## REVISED RESPONSE TO REQUEST FOR ADDITIONAL INFORMATION

### APR1400 Design Certification

Docket No. 52-046

**RAI No.:** 401-8402  
**SRP Section:** 19.03 – Beyond Design Basis External Event (APR1400)  
**Application Section:** 19.3  
**Date of RAI Issue:** 02/08/2016

**Figure 1 –Locations for ECSBS connection**

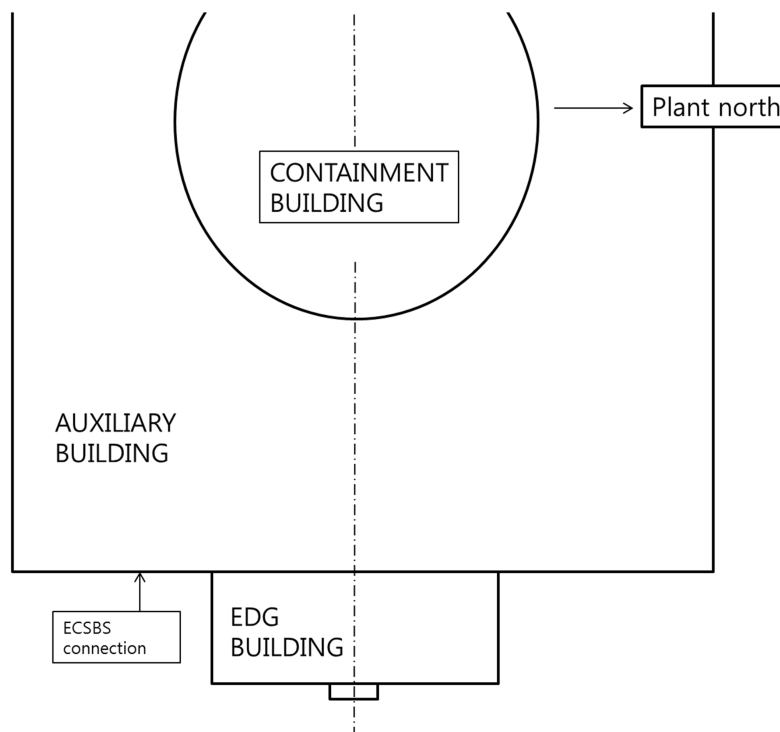
Technical Report APR1400-E-P-NR-14005-P does not contain simplified drawings to show how the FLEX strategy, using the emergency containment spray backup system (ECSBS), is used to maintain containment capabilities. The staff requests that the applicant provide a simplified drawing(s) that identifies the flow path to deliver water to containment. For example the drawing should depict plant piping, valves, pumps, water sources, power needs (as applicable), and any

associated connections (FLEX pump suction, FLEX pump discharge, and fuel supply) and support systems. The staff also requests that the applicant provide the quality classification of installed structures, systems, and components used to maintain containment capabilities. Additionally, the location for any connections should be identified.

The ECSBS can use an external water source from the RWT using the ECSBS FLEX pump, which is connected to the ECSBS via a fire siamese connection located outside of the [Auxiliary Building](#). Please refer to [Figure 1](#) below for illustration. The ECSBS line runs inside the containment building from the fire siamese connection to the ECSBS nozzles.

The ECSBS FLEX pump is self-powered pump (diesel-driven). And the pump is connected to the RWT via a flexible hose on the suction side and is connected to the fire siamese connection via a flexible hose on the discharge side. Fuel is supplied from the diesel fuel oil day tank “A/B” as illustrated in Figure 6-6 of the Technical Report APR1400-E-P-NR-14005-P. [The quality classifications of installed structures, systems, and components used to maintain containment capabilities \(Containment Building, Auxiliary Building, and components of Containment Spray System\) are described in DCD Tier 2 Table 3.2-1 \(Page 1, 12, and 13 of 86\) and Figure 6.2.2-1.](#) A new schematic drawing (Figure 6-7) will be added to the next page of Figure 6-6 and Subsection 5.1.2.5.3 will be revised as indicated in the Attachment.
